**The Arcade, Dewsbury
& 18-20 Corporation Street / 17 Foundry Street**

Design and Heritage Statement Addendum

1705-BDP-AD-XX-RG-Z-00006

DRAWING TITLE
Ground Floor GA Plan as
Proposed

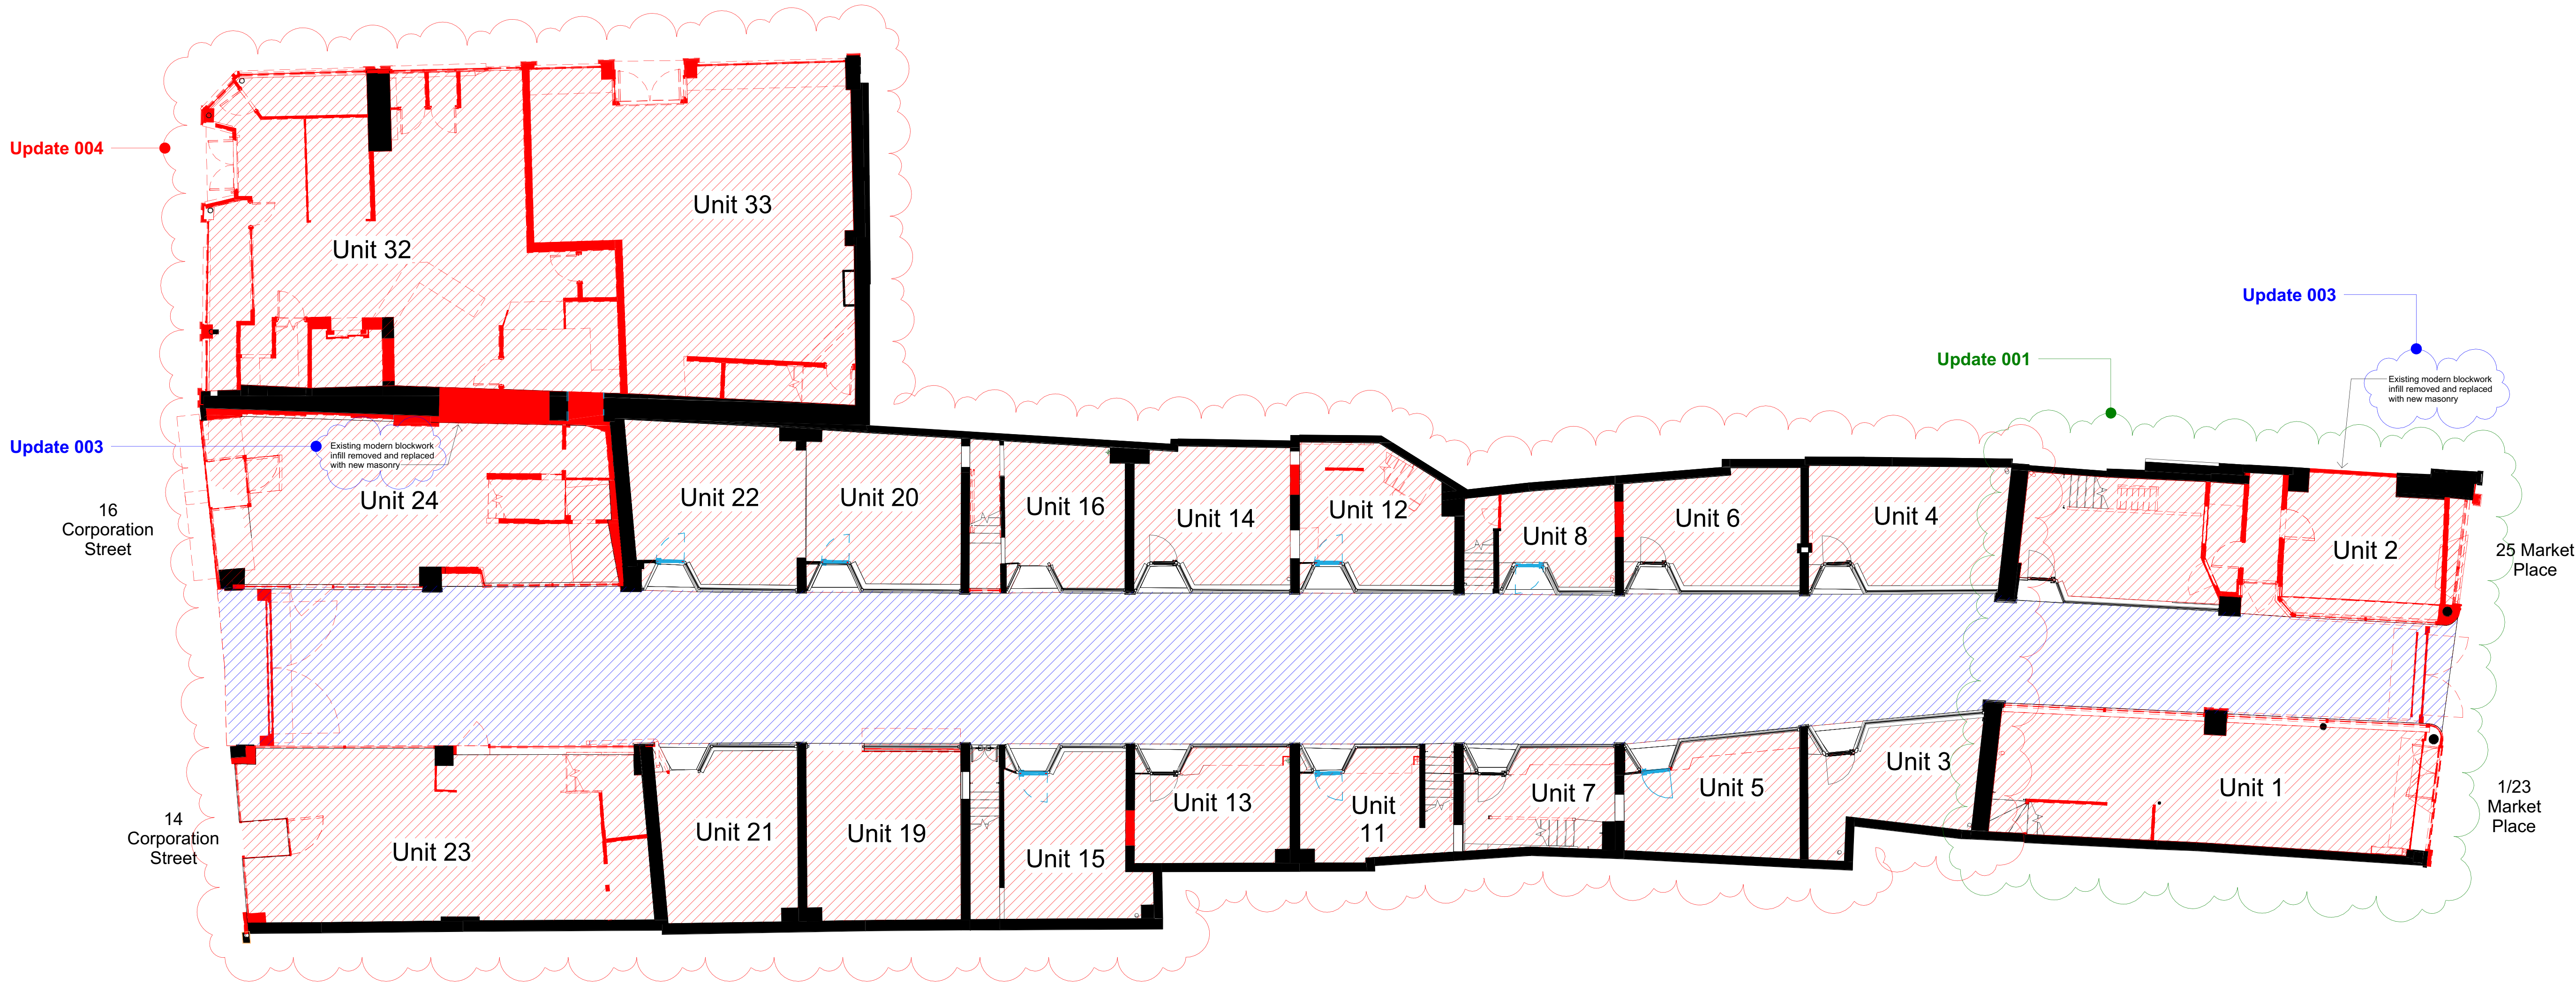
Ref	Location	Element	Original consented proposals	On-site discoveries (where applicable)	Issue caused / Opportunity for improvement	Proposed solution to address issue	Impact (see 1.2)	Relevant drawing(s) as consent	Updated proposed drawings
001	23-25 Market Place Units 1 and 2	Floors	Existing later poorly-constructed steel post and beams within timber suspended floor to be removed.	Following on-site opening up the existing timber floor structure was found to be in poor condition and have wet rot, with numerous steel beams added.	CONDITION + PERFORMANCE: The structural engineer confirmed the existing structure was unsuitable for the proposed building use and could be subject to future decay preventing continued viable and flexible uses.	Replace the suspended timber floor. The location of the floor below the surrounding external ground levels would make the ends of any timber joists prone to rotting (as evidenced on the existing joists and extensive unsuccessful past repair attempts). It is therefore proposed that a concrete suspended floor is installed in these two units.	Minor Adverse	1705-BDP-AD-00-PL-A-20002_T01	1705-BDP-AD-00-PL-A-20002_T02

004	Central Arcade, 14-16 Corporation Street, 18-20 Corporation Street and 17 Foundry Street Units 3-8, 11-15, 19-24, 32 and 33	Floors	Existing floor slab to be locally removed for new building services and then reinstated.	The floor slabs in these units were found to be several thin layers of poor quality screed directly onto the soil, rather than actual slabs. The overall thickness of these layers was considerably thinner than expected for a proper slab.	PERFORMANCE: It would not be possible to dowel into the existing 'slabs' to reinstate areas of slab following the installation of new building services. It could lead to differential settlement between the existing areas of slab and the new infill areas preventing continued viable and flexible uses.	Remove more of the existing screed layers and install complete slabs to these units, to avoid future differential settlement. This strategy has already had consent in unit 16 and slabs are concealed under the consented floor finishes.	Negligible	1705-BDP-AD-00-PL-A-20002_T01	1705-BDP-AD-00-PL-A-20002_T02

PROJECT NUMBER
P3001705
DRAWING TITLE
Ground Floor Removals Plan

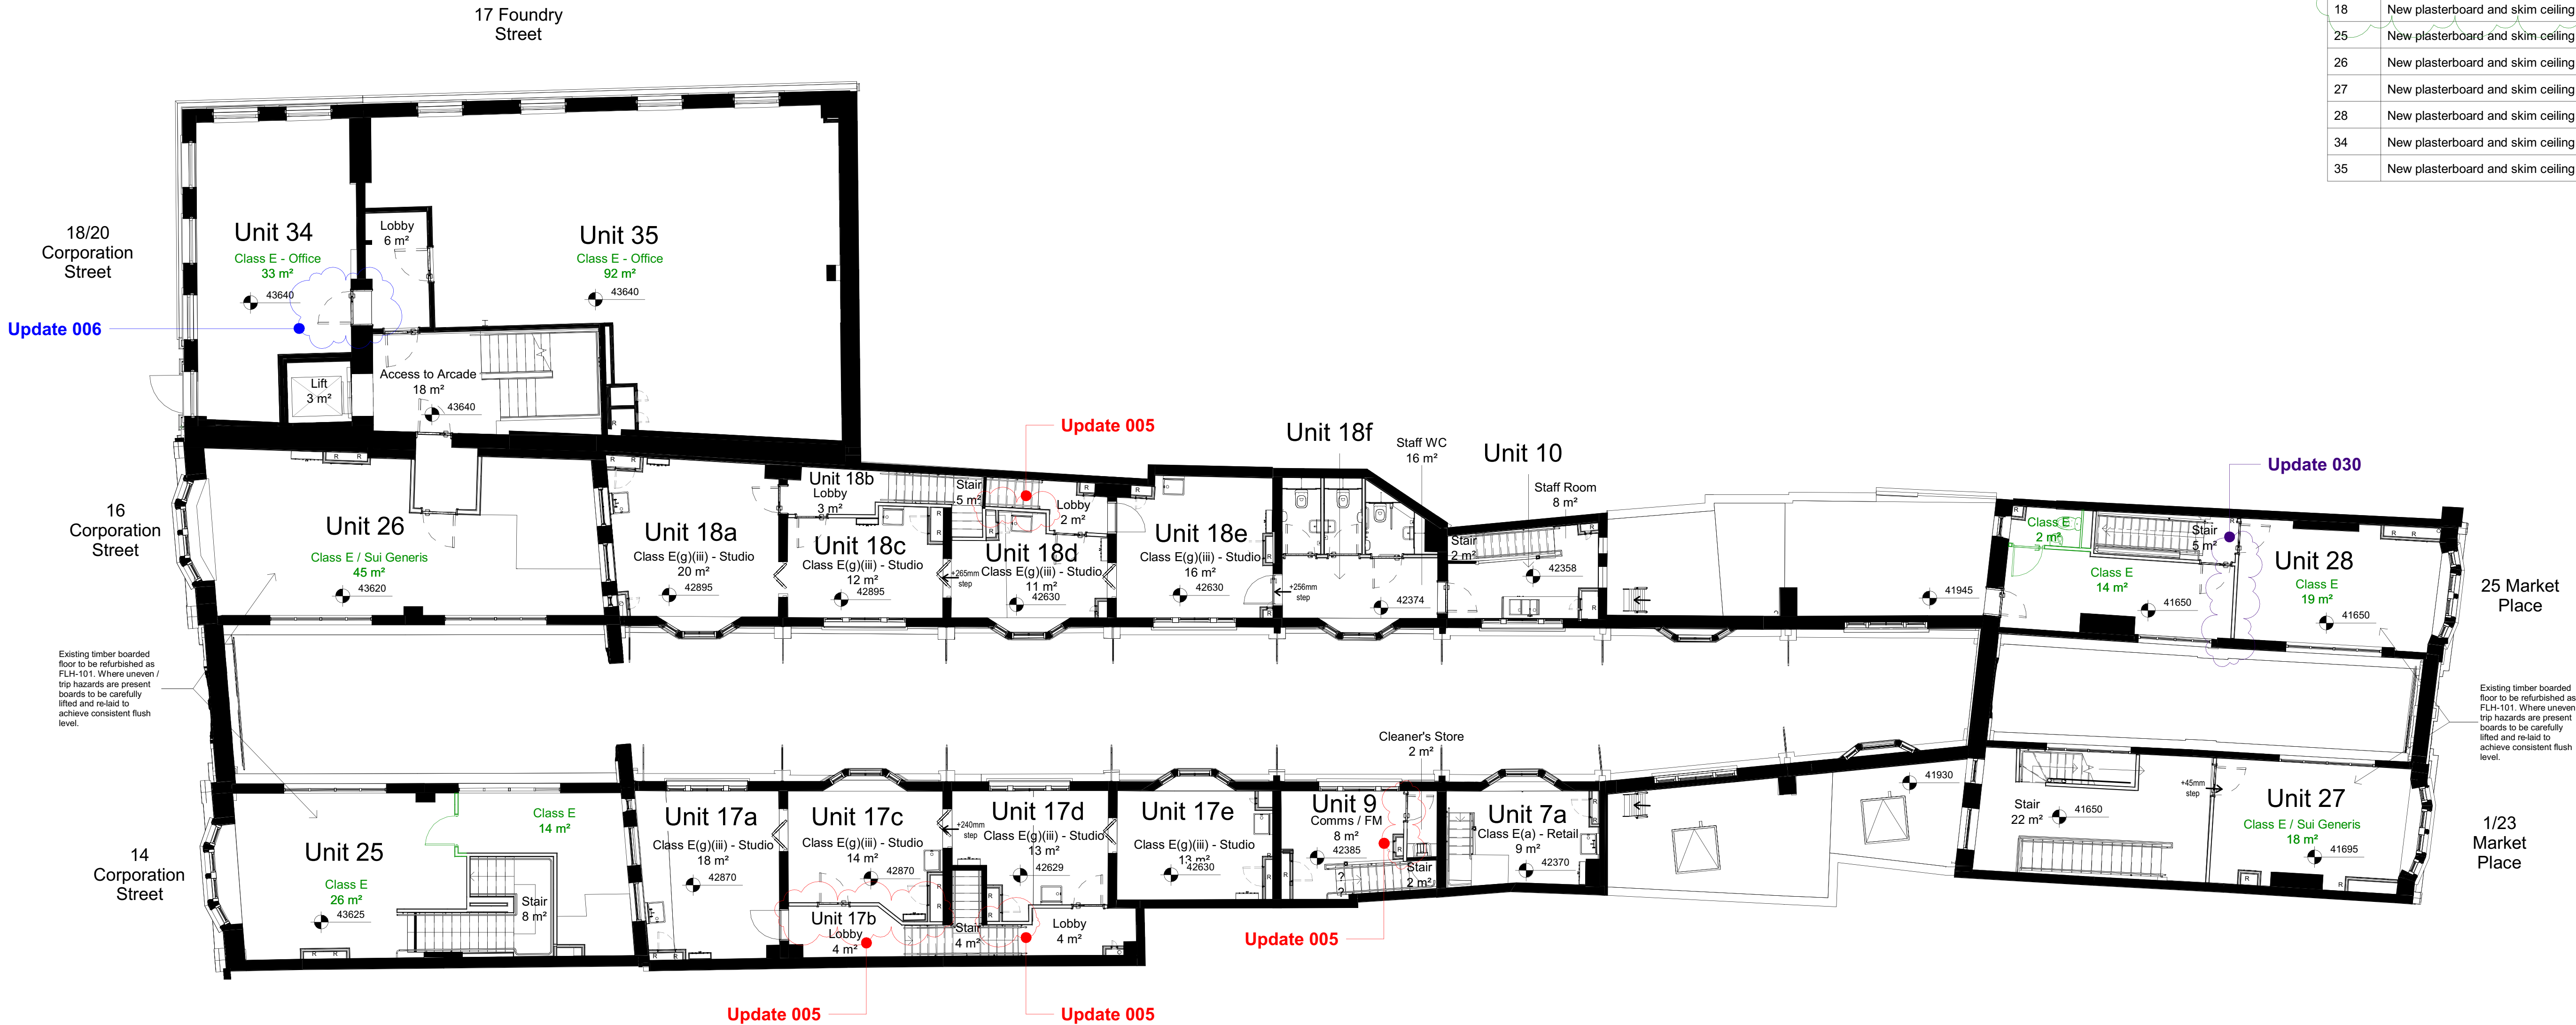
002	25 Market Place Unit 2	Internal partitions	At ground floor, the stair would exit into unit 2.	n/a	LIFE SAFETY: For safe fire evacuation, it is considered necessary for the stair exit to be separated from unit 2 to support continued viable and flexible uses.	Minor change to internal layout with new partition added to separate the stair exit from unit 2, partitions are reversible. This strategy has already had consent in unit 1.	Negligible	1705-BDP-AD-00-PL-A-20001_T01 1705-BDP-AD-SL-PL-Z-00003_T01	1705-BDP-AD-00-PL-A-20001_T02 1705-BDP-AD-SL-PL-A-00003_T02
003	23-25 Market Place and 14-16 Corporation Street	Masonry walls	Existing wall to be retained.	Following on-site opening up and the removal of modern finishes (e.g. plasterboard), several sections of wall have been found to be recent blockwork.	LIFE SAFETY + PERFORMANCE: These blockwork infills are mostly poorly built, not meeting the fire performance requirements or modern structural requirements to support continued viable and flexible uses.	Replace poor quality blockwork infills with new, to meet modern requirements.	Negligible	1705-BDP-AD-00-PL-A-20002_T01 1705-BDP-AD-02-PL-A-20002_T01	1705-BDP-AD-00-PL-A-20002_T02 1705-BDP-AD-02-PL-A-20002_T02

010	23-25 Market Place Unit 29	Door opening	Create a new door opening in unit 29 to allow a space to be separated into a corridor and a room.	n/a	ENHANCEMENT: Opportunity to omit the new door opening and reuse the existing opening for both the corridor and the adjacent room, retaining the historic plan form.	Reconfigure the proposed corridor and omit the new opening in this existing wall	Minor Beneficial	1705-BDP-AD-02-PL-A-20001_T01	1705-BDP-AD-02-PL-A-20001_T02
011	14-16 Corporation Street Unit 30	Floor hatch	Retain existing floor hatch.	Following further on-site investigations, the floor hatch and the trimming around it was found to be structurally unsafe.	CONDITION + PERFORMANCE: The structural engineer confirmed the existing structure could not sustain the required loading performance resulting in likely future failure preventing continued viable and flexible uses.	Remove the access hatch and trimming, and infill the area with concrete to tie into the existing concrete (filler joist) floor structure in this area.	Minor Adverse	1705-BDP-AD-02-PL-A-20002_T01	1705-BDP-AD-02-PL-A-20002_T02

First Floor GA Plan as Proposed

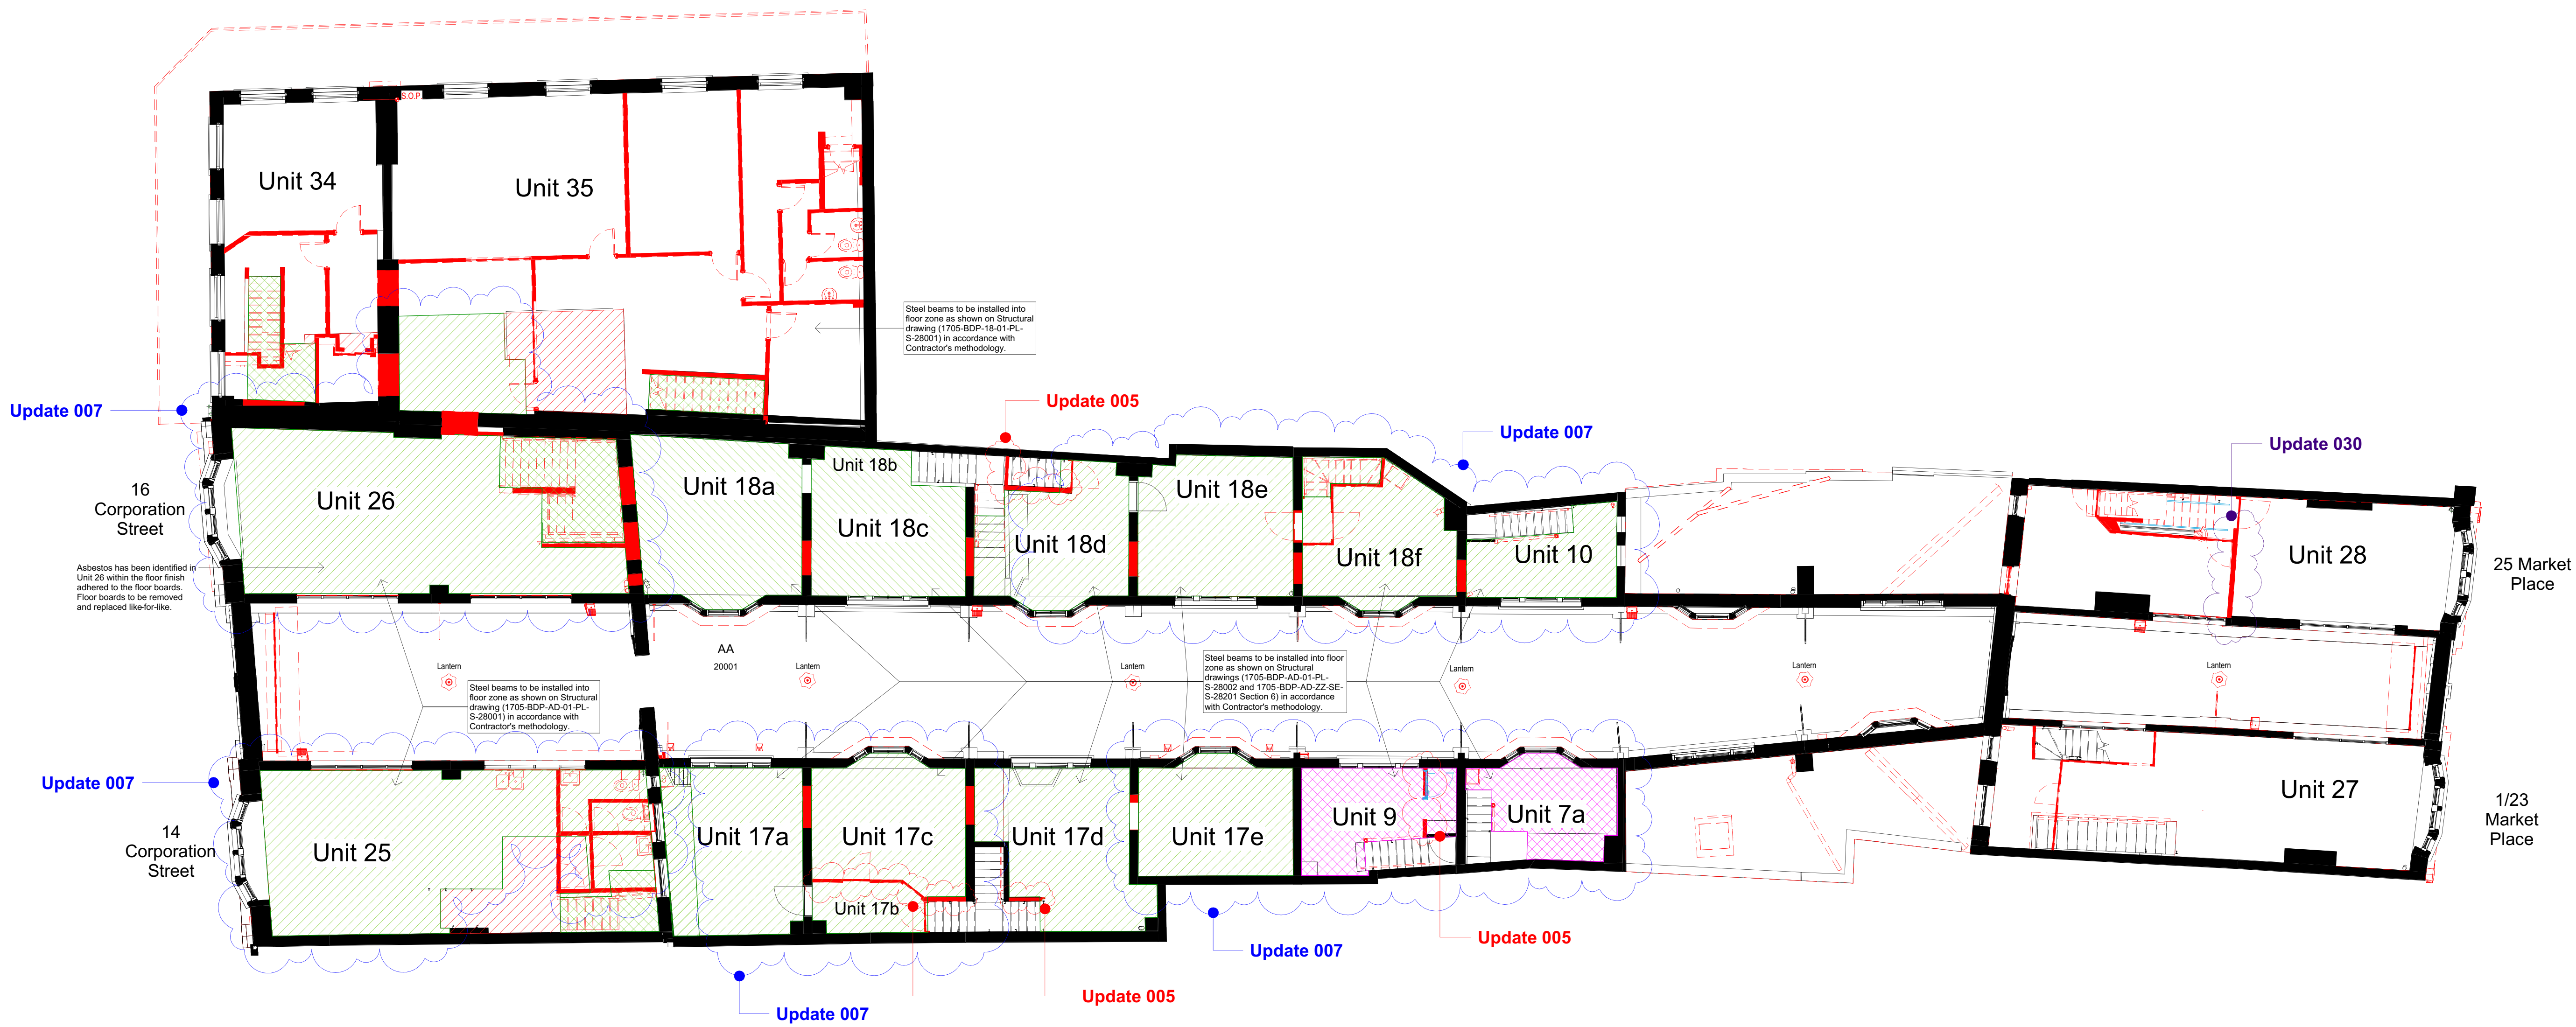
005	Central Arcade Units 9 and 17b	Internal partitions	Existing partitions were assumed to be historic lath and plaster partitions to be retained and upgraded to meet the new fire performance requirements for a 60-minute protected stairway where applicable.	Following on-site opening up, the partitions were found to be a mix of more modern construction and were generally poorly built incorporating hard board / MDF.	LIFE SAFETY + PERFORMANCE: These were not historic elements of the building with heritage value as evidenced by their absence on the historic plans in the West Yorkshire Archives, and it would not be practical to upgrade them to provide 60 minute fire resistance to support continued viable and flexible uses.	Replace these sections of partition with new plasterboard partitions to provide the required fire resistance. This is the same approach that had already had consent for the partitions forming the fire-protected stair in unit 18b on the opposite side of the arcade.	Negligible	1705-BDP-AD-01-PL-A-20001_T01 1705-BDP-AD-01-PL-A-20002_T01	1705-BDP-AD-01-PL-A-20001_T02 1705-BDP-AD-01-PL-A-20002_T02

026	Central Arcade	Glazed roof structure	Cast iron trusses to be redecorated.	Following a fingertip survey of the existing trusses, cracking was noted to the top and bottom chords of several of the cast iron trusses.	LIFE SAFETY + CONDITION: The structural engineer confirmed the cast iron structure was unsafe in its existing poor condition resulting in future failure preventing continued viable and flexible uses Arcade-wide.	Install additional steel principal rafters to carry the roof load and relieve the existing cast iron trusses of their existing load. Cast iron trusses to remain in location and be resupported from the new steel rafters.	Minor Adverse	1705-BDP-AD-RF-PL-A-20005_P01	1705-BDP-AD-RF-PL-A-27001_P02
027	Central Arcade Units 7a, 9, 10, 17, 18	Ceilings	Repair damaged lath and plaster ceilings.	On close inspection, the ceilings were found to be in a poorer condition than expected.	CONDITION: The plaster had extensively debonded from the laths and therefore was not suitable for patch repair.	Remove damaged material and replace with plasterboard. This approach has already had consent for units 25, 26, 27, 28, 34 and 35.	Minor Adverse	1705-BDP-AD-01-PL-A-20001_T01	1705-BDP-AD-01-PL-A-20001_T02
